**Re: Objection to - Greenwich Hospital Redevelopment (Concept) Modification 1**  
**And**  
**Re: Objection to - Greenwich Hospital Redevelopment – Detailed Design**  
**SSD13610238**

**Preamble**

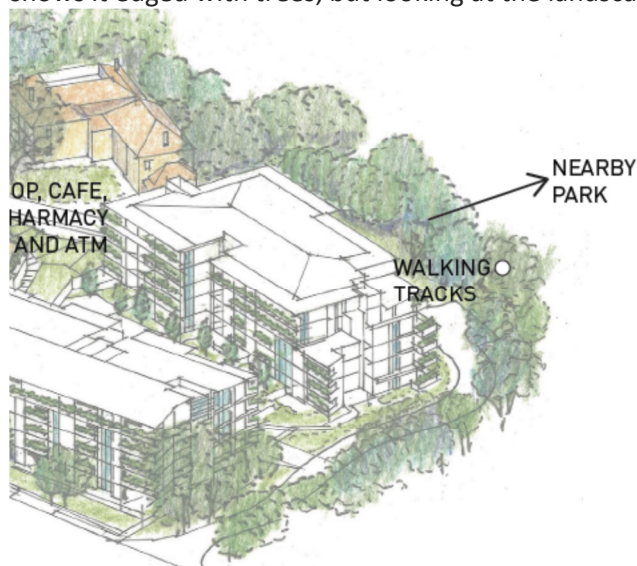
Object to the lack of proof for this statement p 15 in App. K – Traffic & Parking report:

*It is noted that the average people moving into the proposed housing will be 80 years.*

And request clarification or proof.

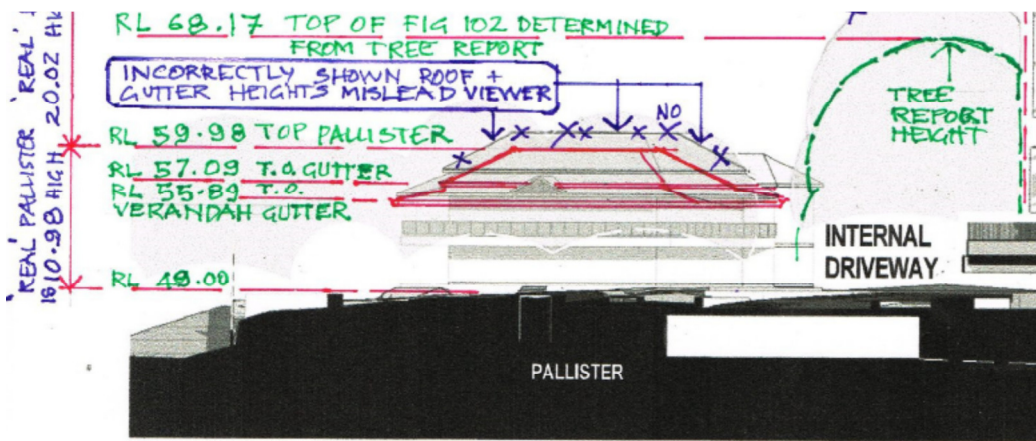
### Object to the misleading use of the wrong ridge height for Pallister House.

Pallister House is the slate roofed building built in 1892. Its maximum ridge line is **RL 59.98** . Attached is a markup submitted by this author previously, alerting to the exaggerated roof height shown for Pallister in the architectural drawings.

It seems now that a disingenuous course of action has been followed, wherein the Applicant and architect have adopted and depicted the wrong ridgeline to use as the maximum ENVELOPE height for the southern Seniors Living building, as shown in the misleading depiction in the drawing extract above and the disingenuous statement p19 of the Mod Report reproduced here for clarity,

**The maximum envelope height for the southern Seniors Building is required by consent conditions to be RL 59.98 because that is the height of the ridge of Pallister House. It is not and never was RL 60.65.**

App. B – Urban Design Report , p23

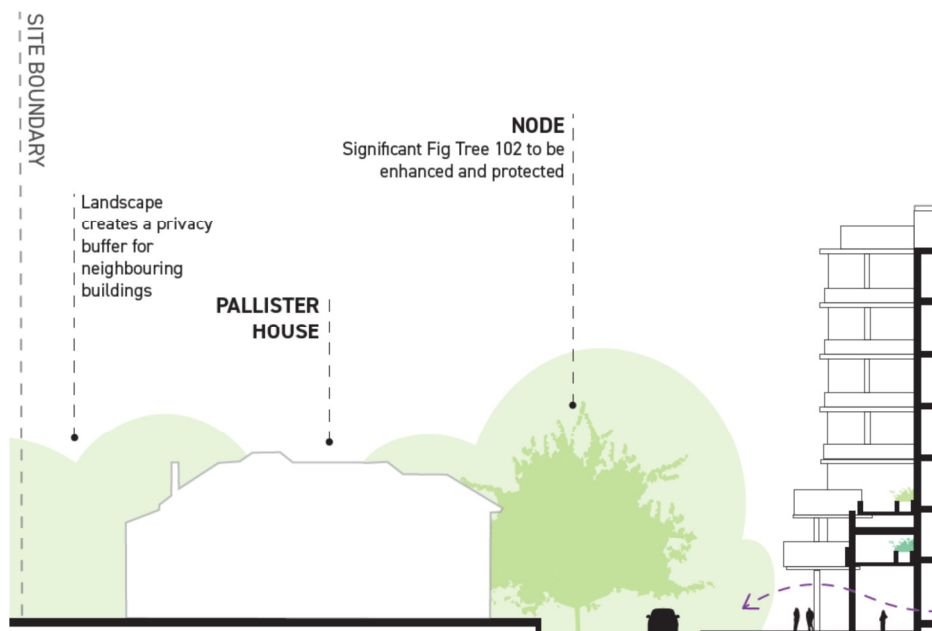
The below extract is from App. B – Urban Design Report , p23, yet again shows a weird and incorrect roofline drawn for Pallister House. The roof is not as high, nor the shape shown, below, nor Fig 102 is not as high.

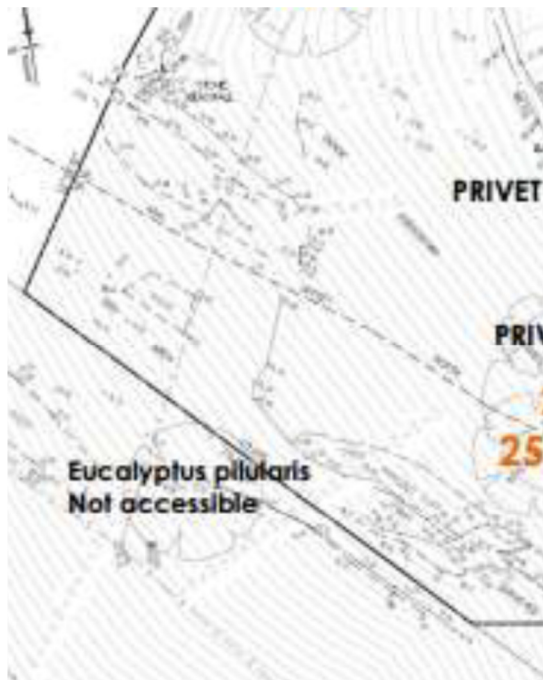
Incomplete Arborist Report : Object that Hammondcare have not produced a tree survey of the of the south-west bushland slope ON THEIR LAND which adjoins the Gore Creek Reserve. It is essential to have the trees positioned on the full area of the bushland south western area. Without this information, it is not possible to know the content of the bushland, monitor impact of the development on

A Biodiversity Report of the Gore Creek Reserve adjoining Hammondcare land must be produced (this was done for other developments adjoining bushland such as behind 266 Longueville Rd).

Left: App I 2 Civil Eng. Plan extract western boundary Right: Appendix E Survey – Page 2 - extract of same portion . Note that Civil Eng. Diagrams overlaid have obscured some of survey linework but it is the same. Clearly, the underlying Survey layer is the same in each extract above.

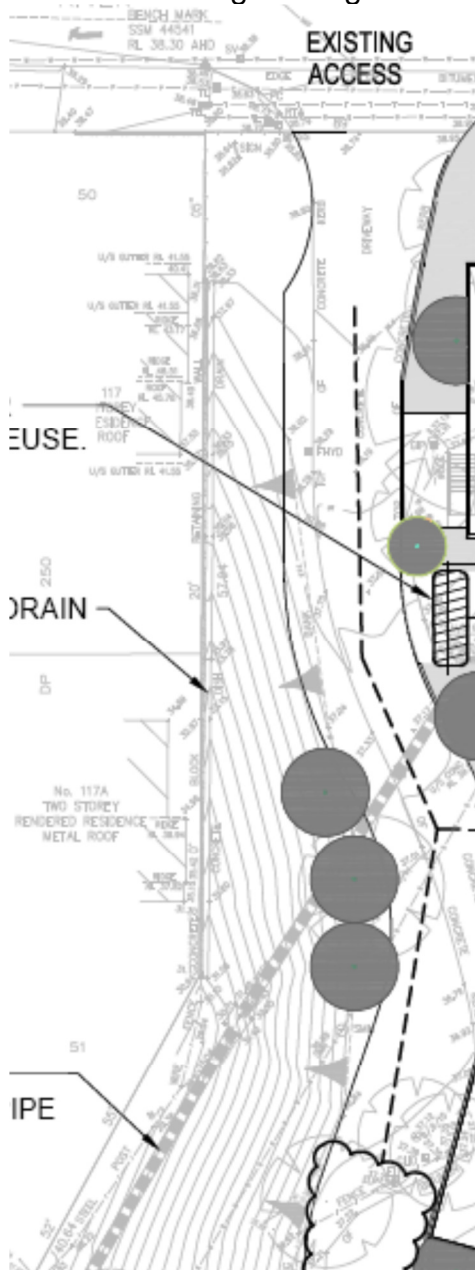
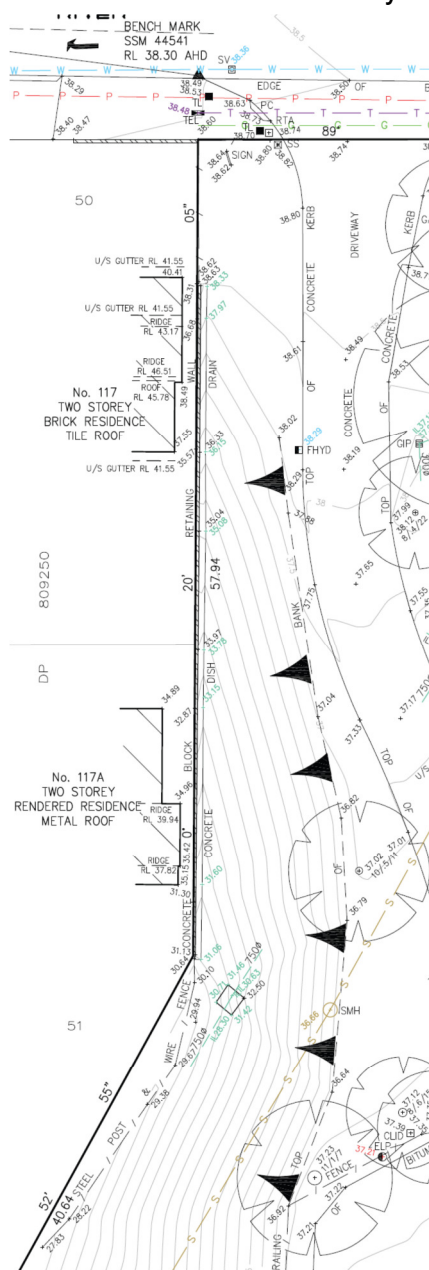
surveyed it, as will be shown. The survey layer used in the underlay to App. I2 Civil Engineering Plan is exactly the same as the App. E Survey (2019 exhibition) by LTS - with one exception - the south-west bushland slope has been omitted from the App. E Survey and replaced with an alternate reality version - even though it shows up in App. I2 Civil Engineering Plan. The correct contours have been known since 2009.

### Underlying Survey layer in Civil Engineering Plan is the same as Survey by LTS

This can be shown by comparing extracted portions from both plans.

The **exception** is that portion of S-w Bushland slope in Survey is not the same as shown in Civil Eng. Plan
